TECHNICAL SERVICE BULLETIN

FRONT DOOR GLASS RUN CHANNEL REPLACEMENT

TSB: BOD107 (Rev1) Sedona (VQ) August 2014

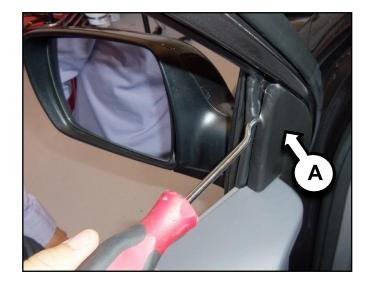
This bulletin provides information on some Sedona (VQ) vehicles, produced from June 15, 2005 through May 06, 2013, which may experience wind noise coming from the front door window/door frame area, at highway speeds, and/or glass run channel deformation caused by improper sealing of the front windows. To correct this concern, follow the procedure outlined in this bulletin to replace the left and right side front door glass run channels. See the table below to properly identify the left and right hand run channels.

Left Hand (LH)	Right Hand (RH)			
(P/N 82530 4D001QQK)	(P/N 82540 4D001QQK)			
ELECTION OF THE PARTY OF THE PA
